RESPONSE TO QUESTIONS ON BROWNS FERRY RECONSTITUTED FUEL

Reference: Letter from S. Black to O. D. Kingsley, Jr., dated September 13, 1989, "Revised Reload Technical Specifications (TAC 00450) (TS 254) Browns Ferry Nuclear Plant Unit 2"

Response to NRC Region II Questions
Browns Ferry Reconstituted Fuel

FIGURE 1

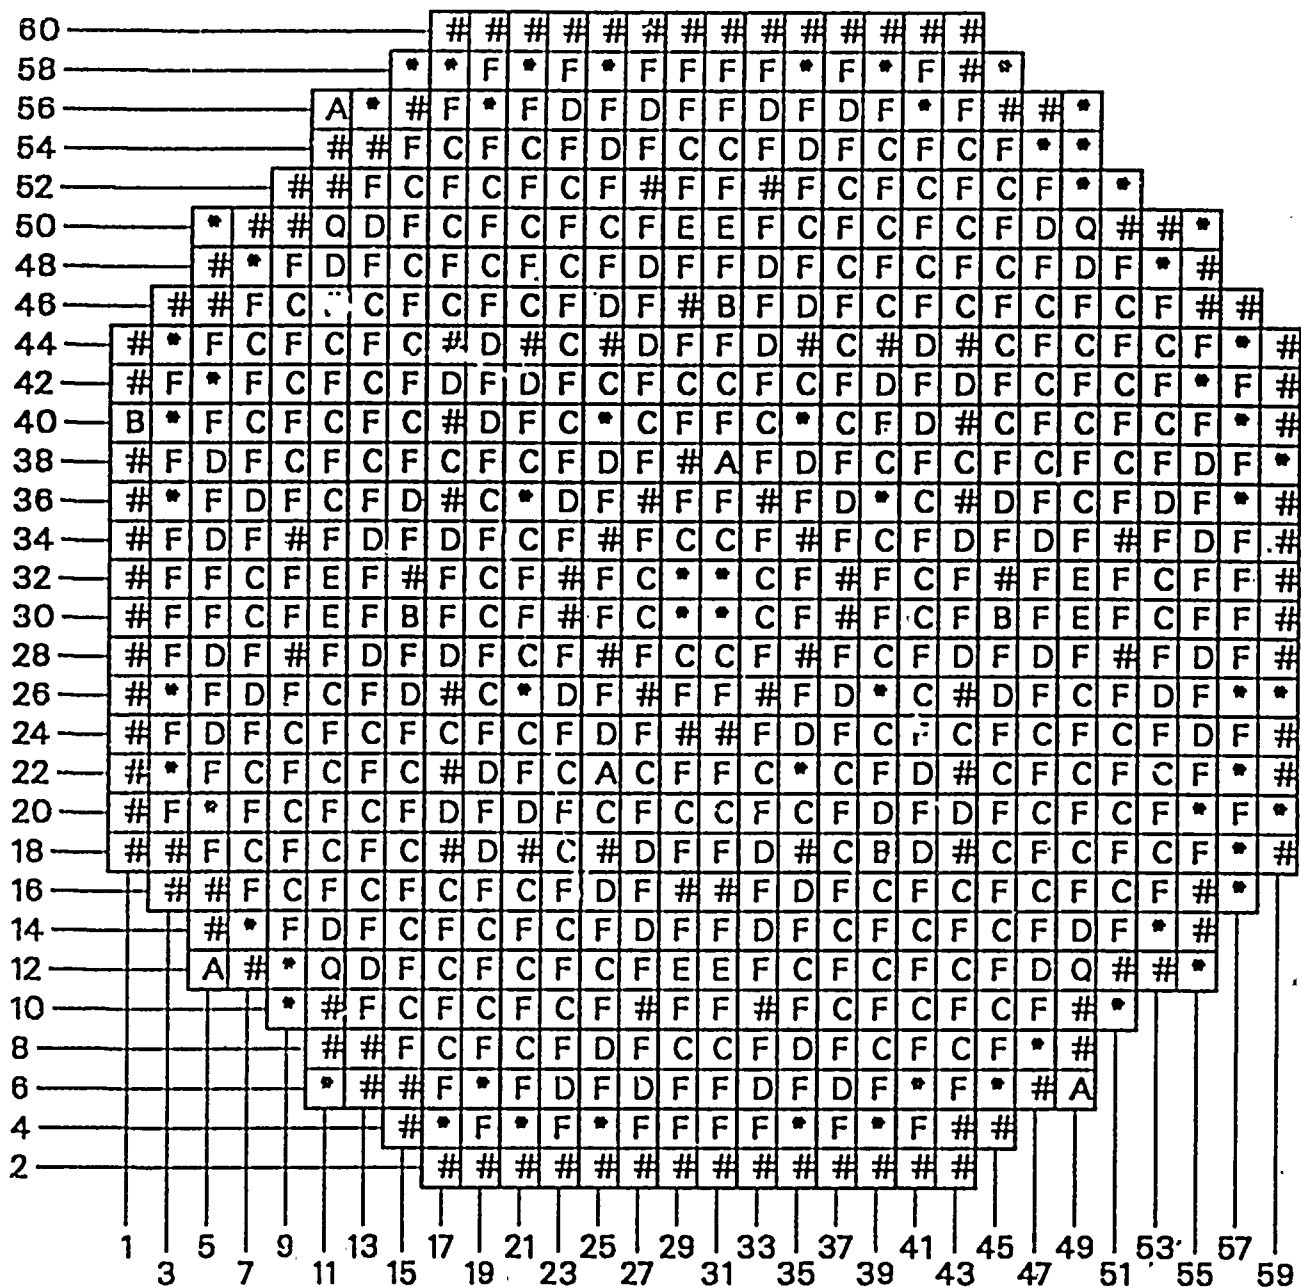
Does Figure 4-5 of the Summary Report represent the actual final loading pattern? If not, please provide an updated final loading pattern map.

The final loading pattern has changed slightly from that given in the Summary Report. Several Reload 2 and 3 bundles have been swapped in order to increase the cycle length allowed within licensed exposure limits for the fuel. Only one swap exchanged bundles from a different reload batch. As a result, a Reload 3 bundle now resides in core location 27-10 and a Reload 2 bundle is in location 19-56. This change is reflected in the revised final loading pattern map given in Figure 1.

It should be noted that the swapped bundles are high in exposure (low reactivity) and have the same nuclear design. An evaluation showed that the change in loading pattern does not invalidate the conclusion given in the Summary Report, ie that the final core design meets all design criteria and the current operating limits are valid.

Figure 3: Lead Bundle Power

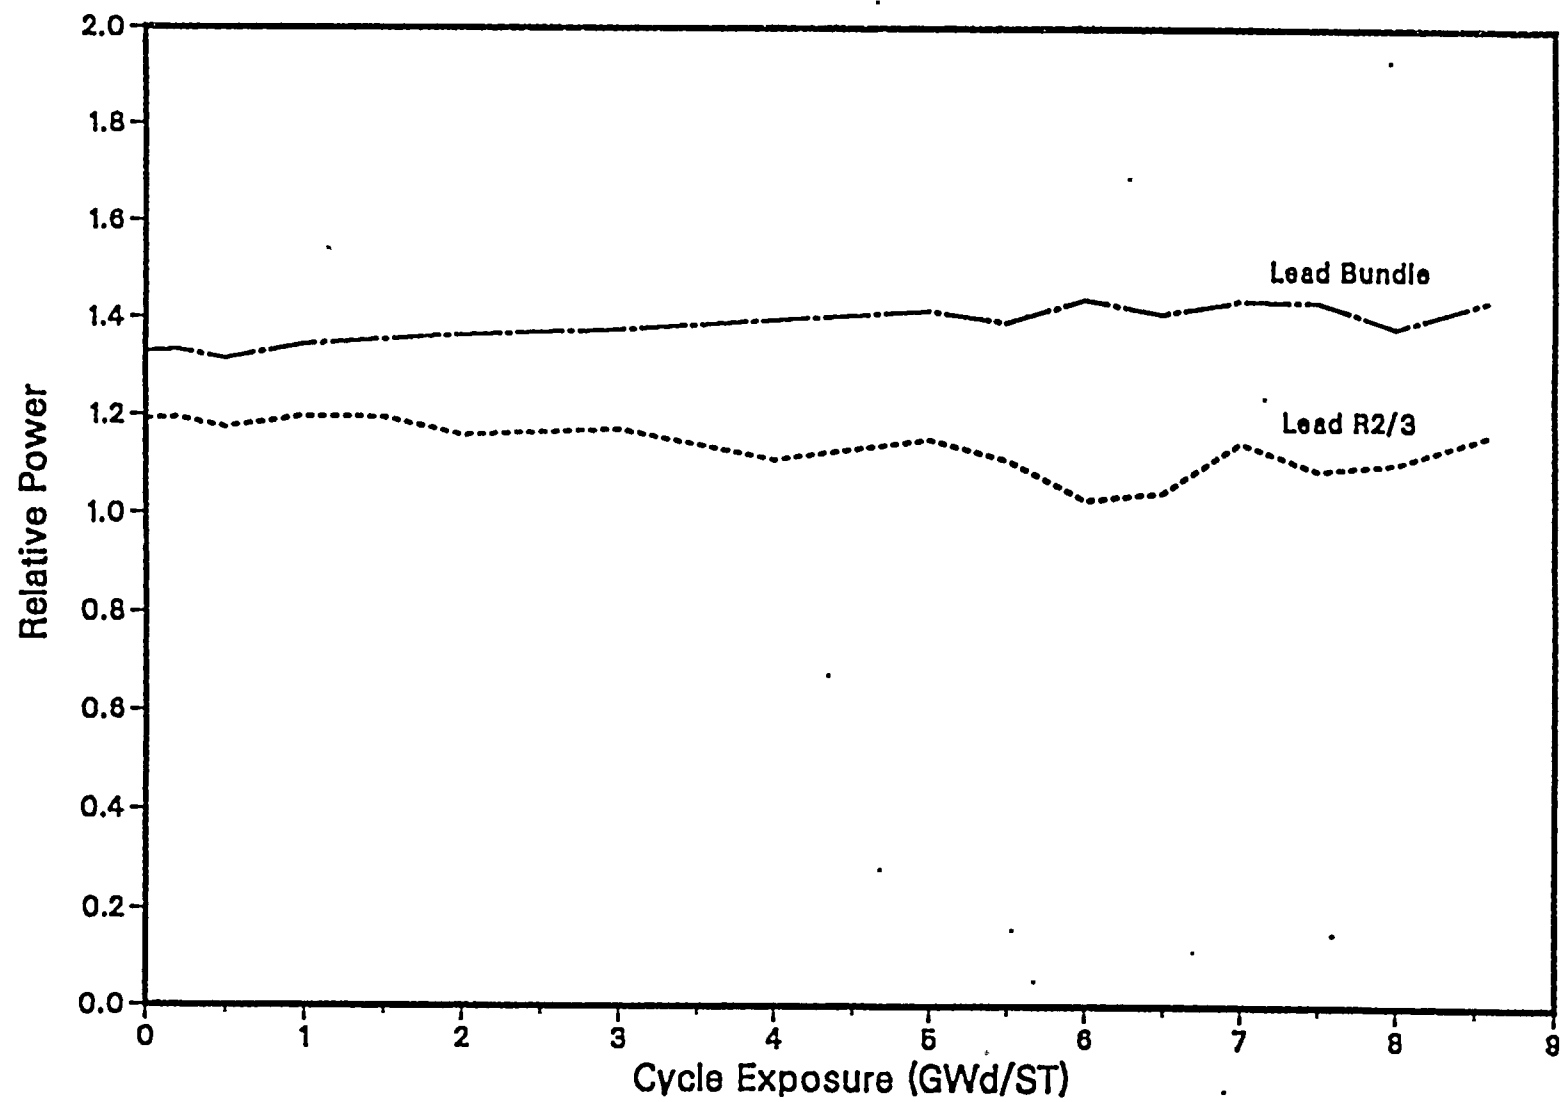
What is the typical bundle power experienced by reconstituted fuel during the cycle? Please provide results for maximum, average, and minimum power bundles.

Figure 3 compares the maximum power of the Reload 2 and 3 bundles to the lead bundle power for the entire core. The results show that Reload 2 and 3 (ie reconstituted) fuel will operate through the cycle with significant margin to the maximum power bundle in the core. This result is expected since Reload 2 and 3 are the highest exposure bundles in the core.
